UNITED STATES PATENT AND TRADEMARK OFFICE

Office Action Summary

09/910,960

DETAILED ACTION

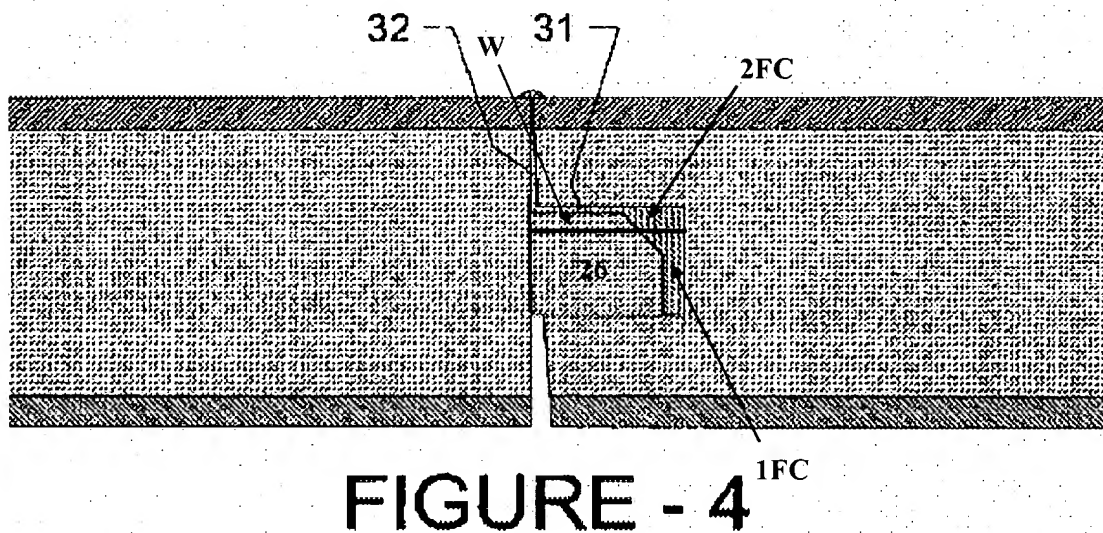
Claims 3-7, 9-15, 18-25 are rejected under 35 U.S.C. 103(a) as being unpatentable over Nelson (US 5,618,602) (see marked-up figure below) in view of Martensson (WO96/27721).

Claim 7 (Independent). Nelson shows and discloses a guiding means at a joint between adjacent boards 10, said boards comprising an upper surface 12, and a core 13, and bounded by edges, at least one of said edges comprising a groove 16 or a tenon 26, said tenon 26 comprising a plurality of guiding wedges **W** (comprised of portions of 27 and 30) wherein the tenon 26 has an angled distal surface and at least one of said guiding wedges **W** is positioned between said angled distal surface and the core 13, wherein a fitting clearance between the tenon 26 of a first of said boards and a groove 16 of the adjacent board includes a first fitting clearance **1FC**, the first fitting clearance **1FC** being bounded by a distal end 29 of the tenon 26 and a proximal part 19 of the groove 16, and a second, guiding, fitting clearance **2FC** which second, guiding, fitting

clearance **2FC** being bounded by, on at least one side, said guiding wedge **W**, whereby the first fitting clearance **1FC** comprises the main part of the fit and the second, guiding, fitting, clearance **2FC** comprises a smaller part of the fit, and said guiding wedge **W** comprises a distal angled surface **30** and a section **27** extending from said distal angled surface **30** of said guiding wedge to said core **13** (see figures 1-8, *especially* figure 1 and annotated figure 4 below). Nelson fails to disclose that the at least one guiding wedge comprises a plurality of guiding wedges arranged perpendicular to the extension of the joint. Martensson, teaches guiding wedges **9** arranged perpendicular to the extension of a joint in order to strengthen the joint connection. In any event, duplicating the components of a prior art device is a design consideration within the skill of the art. In re Harza, 274 F.2d 669, 124 USPQ 378 (CCPA 1960). Therefore, it would have been obvious to one having ordinary skill in the art at the time the invention was made to include a *plurality* of guiding wedges arranged perpendicular to the extension of the joint, as taught by Martensson, in order to strengthen the joint and further since duplication of components is within the ordinary skill of the art.

The applicant argues that the Martensson guiding wedges (9) are arranged parallel to rather than perpendicular to the joint between the boards. This is not persuasive. The mortice and tenon joint of Martensson extends parallel to the boards whereas the Martensson wedges (9) extend upwards and downwards from the tenon, thus meeting the limitation of perpendicular to the joint.
